PAMMEL STATE PARK
HARMON TUNNEL HIGHWALL (BLUFF) SCALING
MADISON COUNTY, IOWA
PROJECT NUMBER: 26-04-61-02

June 18, 2026

NE Entrance High Bluff Surface Area

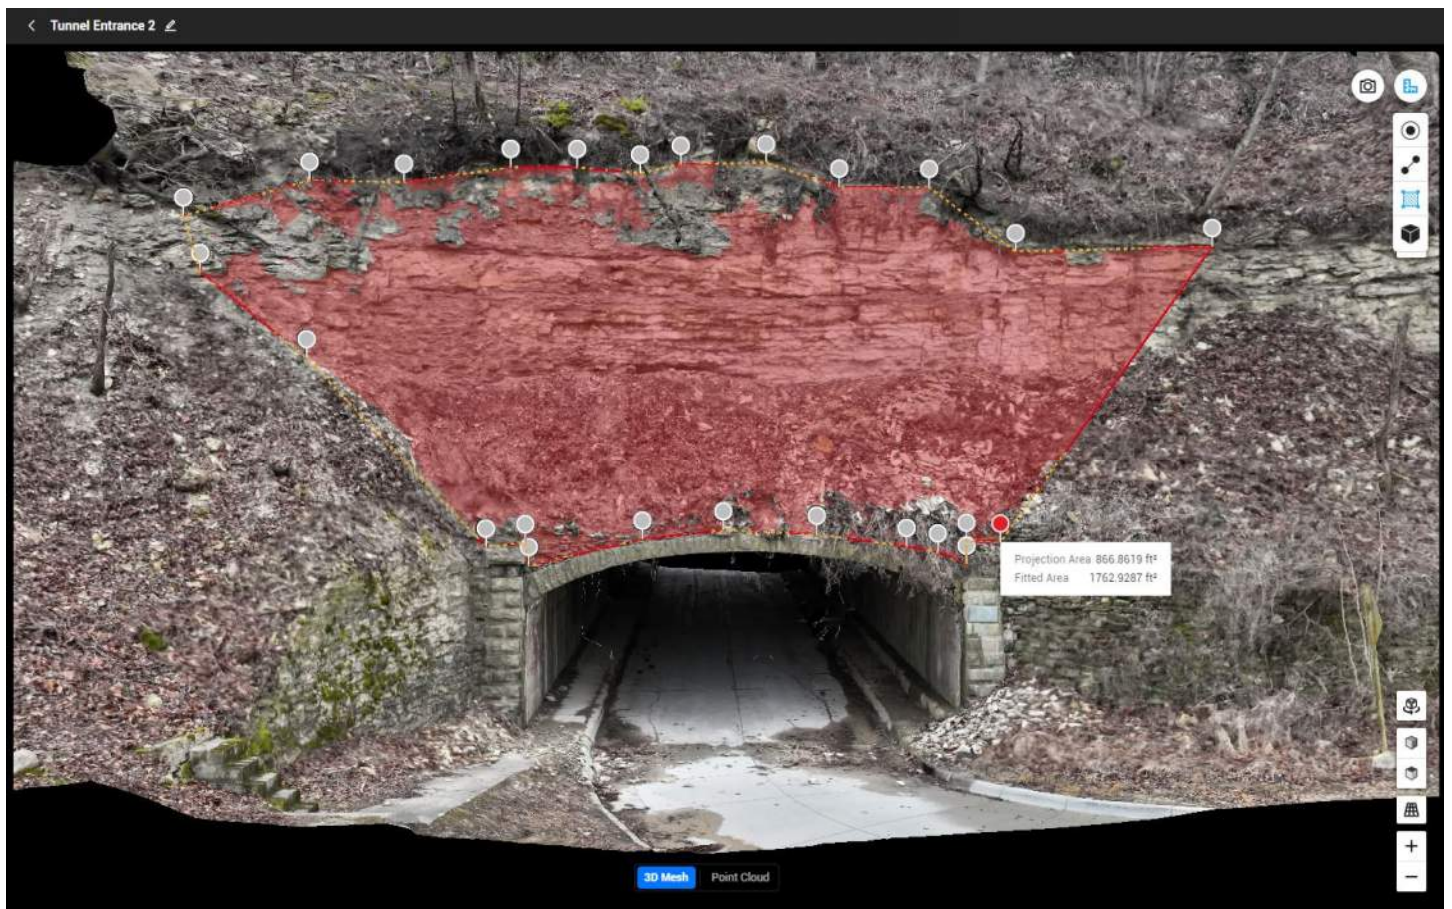
Q: How about the length of the highwall on each side?

A: Dimensions are given in the following photos which can also be found at this link:
